ADDENDUM #1

255 Hamilton Street Demolition:

255 Hamilton Street Partial Demolition Contractor Questions and RHA Answers

From: Peter L. Morse AIA
To: Jim Singer – Rochester Housing Authority
CC:
Date: 2.27.2026
Re: 255 Hamilton Street – RHA Duplex Renovation – Phase 1
(Added Demolition Scope)

DRAWING TITLE
DEMOLITION PLAN - FIRST FLOOR

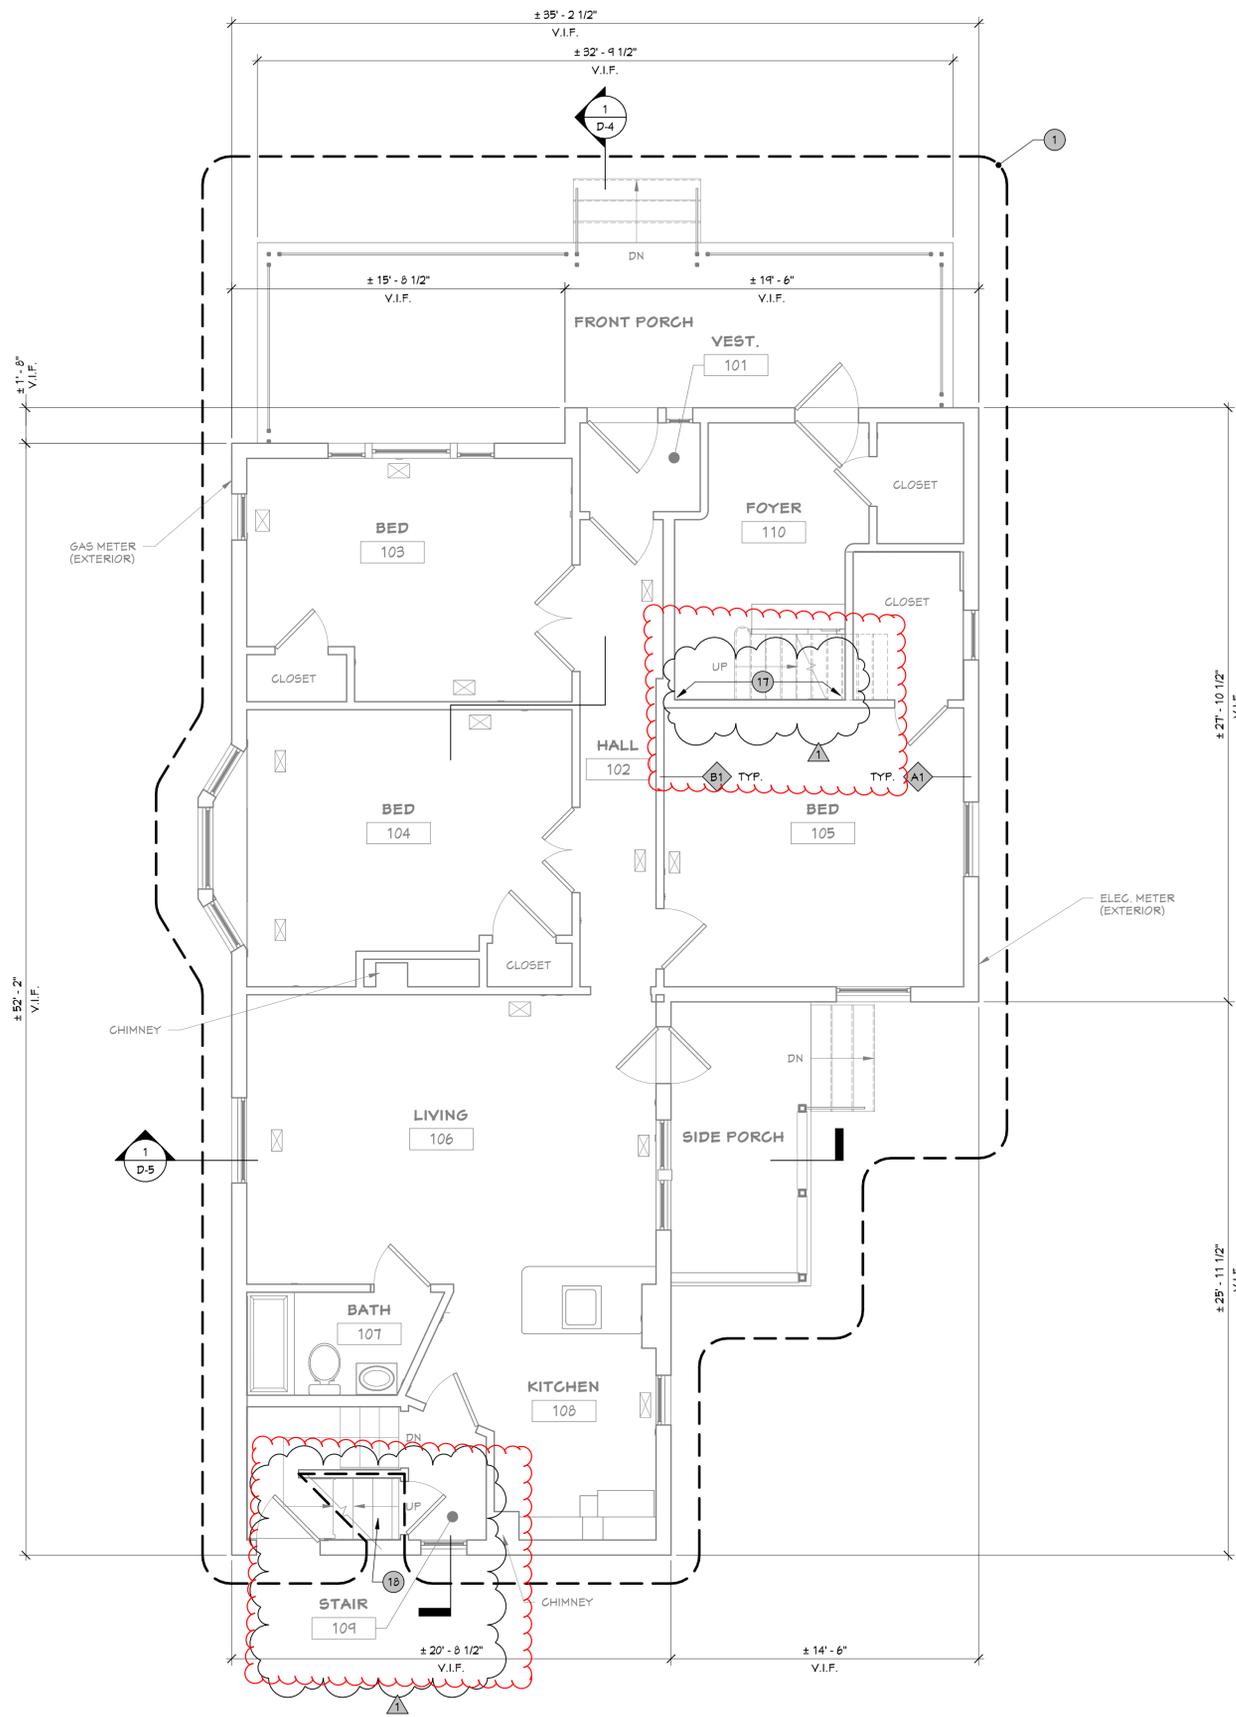
1. Add to scope - Sheet D-2, Keynote #16:
 - a. REMOVE AND DISPOSE OF ATTIC FLOOR ASSEMBLY AND MODIFY FRAMING AS REQUIRED TO ACCOMMODATE FUTURE ATTIC ACCESS HATCH.
2. Add to scope - Sheets D-1 and D-2, Keynote #17:
 - a. REMOVE AND DISPOSE OF WALL FINISH MATERIALS AND SUBSTRATES ON INTERIOR FACE OF STAIRWAY WALLS BACK TO STUDS DOWN TO FIRST FLOOR. STAIRS AND HANDRAILS SHALL REMAIN, PROTECT FROM DAMAGE DURING DURATION OF WORK.
3. Add to scope - Sheet D-1, Keynote #18:
 - a. REMOVE AND DISPOSE OF ALL WALL AND CEILING FINISH MATERIALS IN STAIRWAY DOWN TO FIRST FLOOR DOOR.

- REMOVE AND DISPOSE OF ATTIC FLOOR ASSEMBLY AND MODIFY FRAMING AS REQUIRED TO ACCOMMODATE FUTURE ATTIC ACCESS HATCH.
 - REMOVE AND DISPOSE OF WALL FINISH MATERIALS AND SUBSTRATES ON INTERIOR FACE OF STAIRWAY WALLS BACK TO STUDS DOWN TO FIRST FLOOR. STAIRS AND HANDRAILS SHALL REMAIN, PROTECT FROM DAMAGE DURING DURATION OF WORK.

- REMOVE AND DISPOSE OF ALL WALL AND CEILING FINISH MATERIALS IN STAIRWAY DOWN TO FIRST FLOOR DOOR.
